## TECHNICAL ANALYSIS

Tank Seam Road  
Co-Op Mining Company  
Bear Canyon Mine  
ACT/015/025

July 20, 1994

# SB-SLOPE

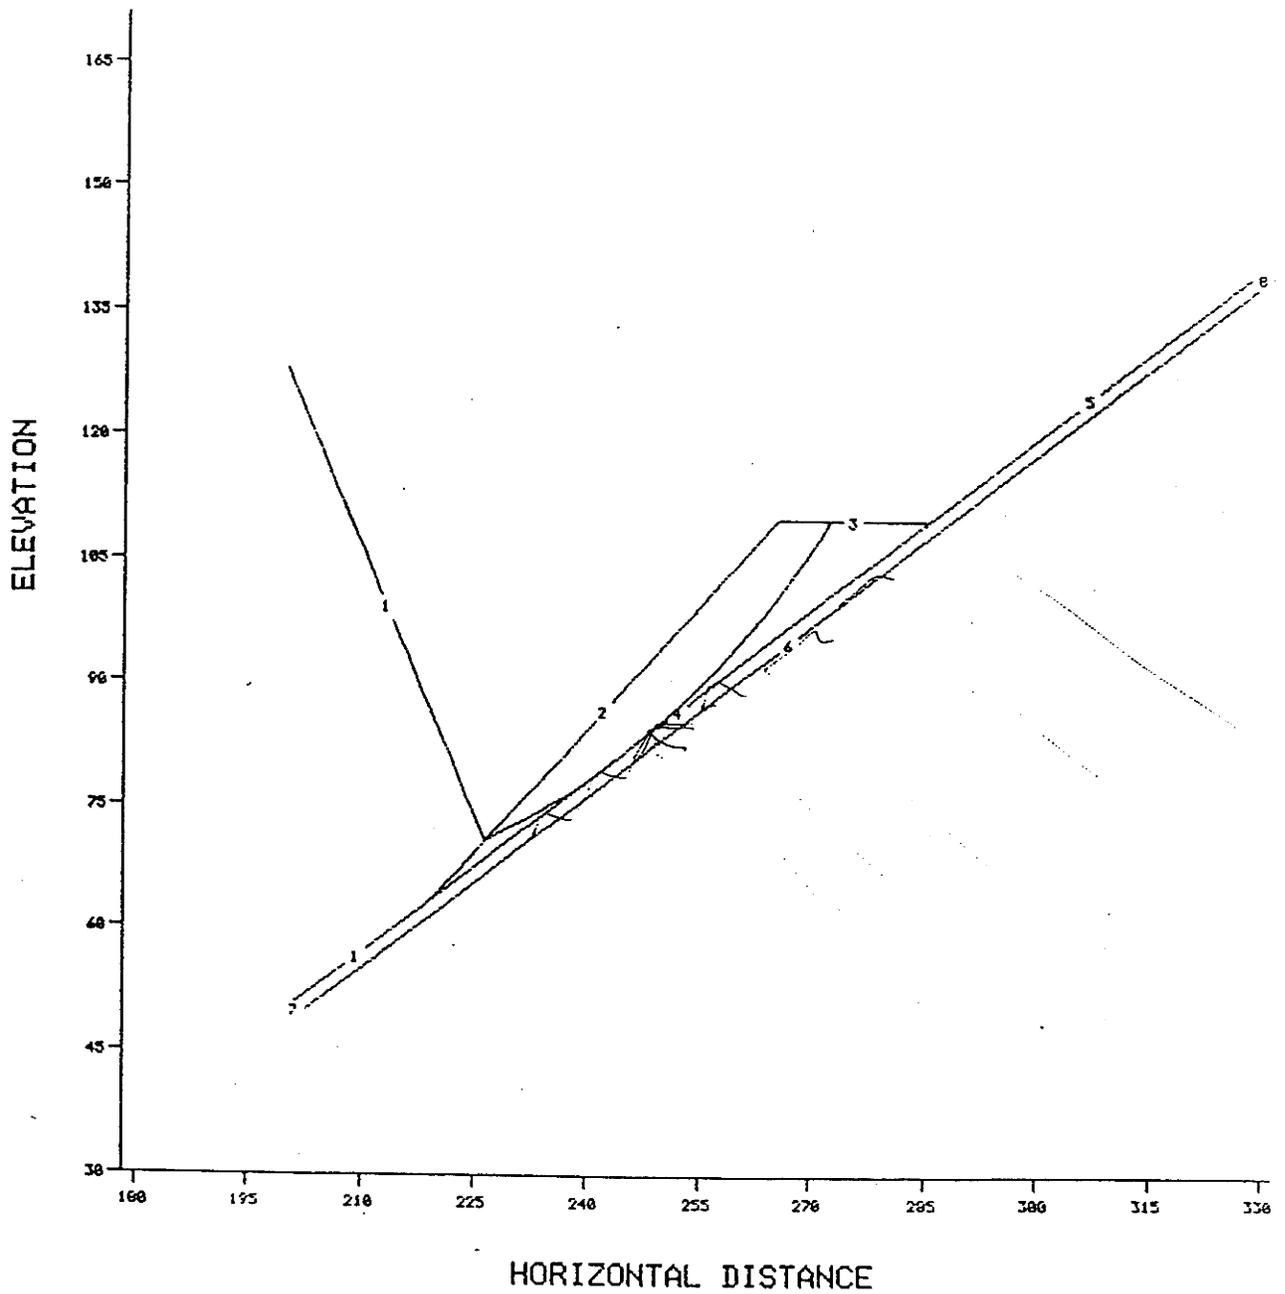
SB-STABLE found some failure surfaces that went from the fill into the natural soil, into the bedrock, and the back into the natural soil and fill. That type of failure seemed unlikely to the Division. To prevent such failure from occurring in the model the Division increased the rock's strength parameters in the model. Failure surfaces with safety factor of 1.1 were found using the modified profile.

The Division informed Co-Op Mining of the results and they passed the analysis on to Dames and Moore. In a draft letter to Co-Op, Dames and Moore stated the slope's profile in the initial study had been overly simplified. Instead of a smooth slope with a uniform soil cover the natural slope consisted of bedrock "steps". The bedrock is exposed in some areas of the slope and covered with 2 to 3 feet of soil in others. Dames and Moore felt that if bedrock steps were added to the model, then the natural slope would not fail.

The Division then modified its model by assigning rock properties to all areas of the natural slope. Safety factors of 1.31 were discovered for some failure surfaces.

When the Division analyzed the slope using Dames and Moore revised assumptions the safety factor was 1.31. When saturated soil conditions were assumed the safety factor dropped to 1.29. The regulations require road embankments to have safety factors no less than 1.3.
